# ***RLBLOCA Rev. 0 Transition Review*** ***RLBLOCA Rev. 2 Program Discussion***

***Transition Program - Bert Dunn***  
***RLBLOCA Revision 2 Discussion - Ken Carlson***

**May 7, 2008**  
**Rockville, Maryland**

## *Specific Issue – Break Spectrum, Disposition of Breaks between SBLOCA and RLBLOCA*

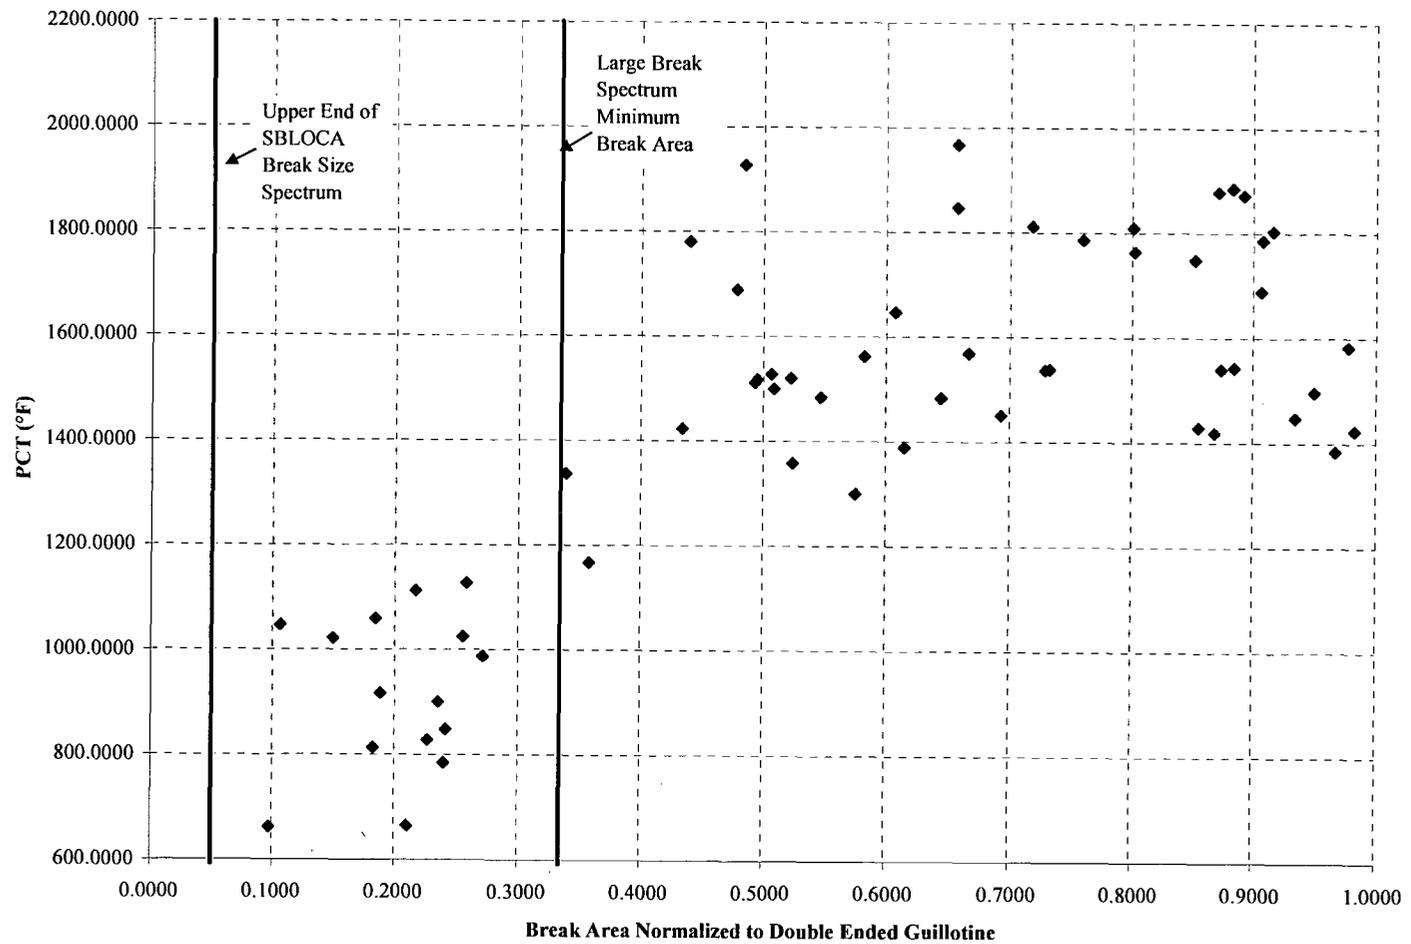
- ◇ The use of probability sampling theory to satisfy the acceptance criteria for peak cladding temperature, maximum local oxidation, and core wide oxidation should be limited to breaks falling within the appropriate phenomenologically-driven region

- ◇ The RLBLOCA methodology has been modified as follows:
- ◇ Consistent with Regulatory Guide 1.157, the split and guillotine type breaks both span the complete break size range up to the largest possible break
- ◇ Lower end of break spectrum adjusted to approach .2 to .3 times the double ended Break Area

- > **Minimum PCT Difference – Large to Intermediate Break**
  - ◇ **73 cases examined none are limiting and only one within 450 F**
